Proposal for Amendment 3 to UN Global Technical Regulation No. 9 (Pedestrian safety) *

Submitted by the Chair (Republic of Korea) of the Informal Working Group on the Deployable Pedestrian Protection Systems of UN Global Technical Regulation No. 9

The text reproduced below was prepared by the experts of the Informal Working Group (IWG) of the Deployable Pedestrian Protection Systems (IWG-DPPS) on UN Global Technical Regulation No. 9 and proposes provisions on DPPS. It supersedes ECE/TRANS/WP.29/GRSP/2023/6. The modifications to the existing text of the UN Global Technical Regulation No. 9 (ECE/TRANS/180/Add.7, Corrs.1 and 2, Amends.1 and 2) are marked in bold for new or strikethrough for deleted characters.

"Figure 11

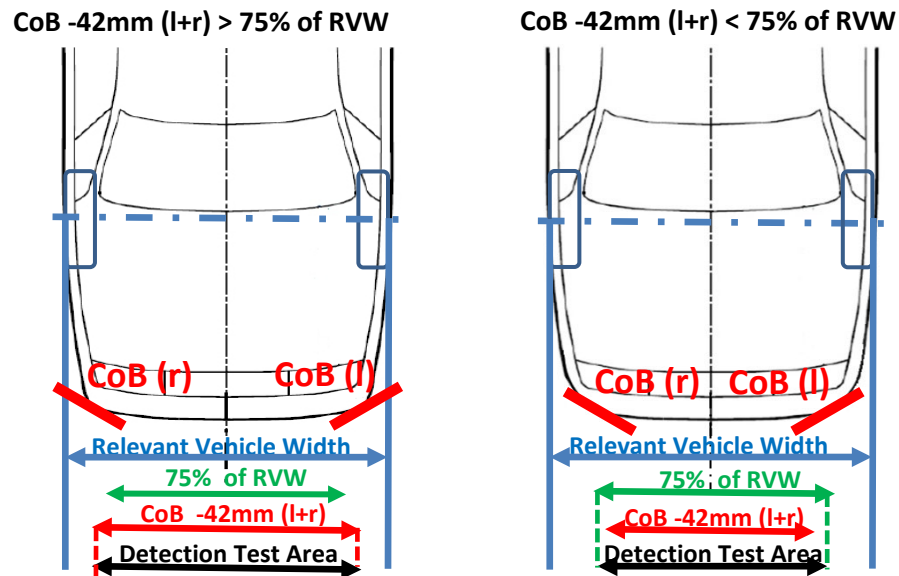
- 3.19.** "Detection test area" is the area designated to detect a pedestrian in order to ~~initiate the activate ion~~ of the deployable system. The width of the detection test area shall be the relevant vehicle width, minus a distance from each side of 12.5 per cent of the relevant vehicle width, but not more than 250mm from each side. The detection test area must not be smaller than the area inboard of the corners of bumper (CoB) minus a distance of 42mm on each side, as measured horizontally and perpendicular to the longitudinal median plane of the vehicle. (see Figure 11)."

Insert new Figure 11, to read:

Determination of the Detection Test Area (see paragraph 3.19): examples

Figure 1-1
Deployment Time History Curve

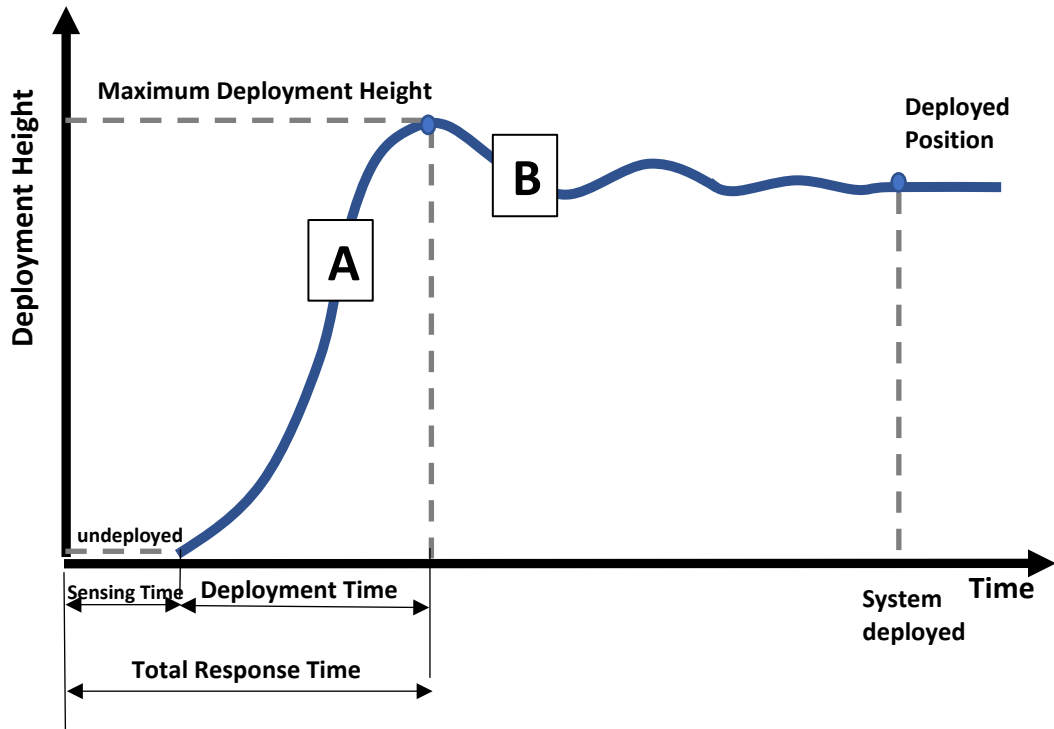
- (a) In case of $HIT_d < TRT$, the **headform** test shall be performed dynamically **at the timing of the head impact**;
- (b) In case of $HIT_d \geq TRT$, the **headform** test may be performed either statically at a height no more than the deployed position or dynamically **at the timing of the head impact**.
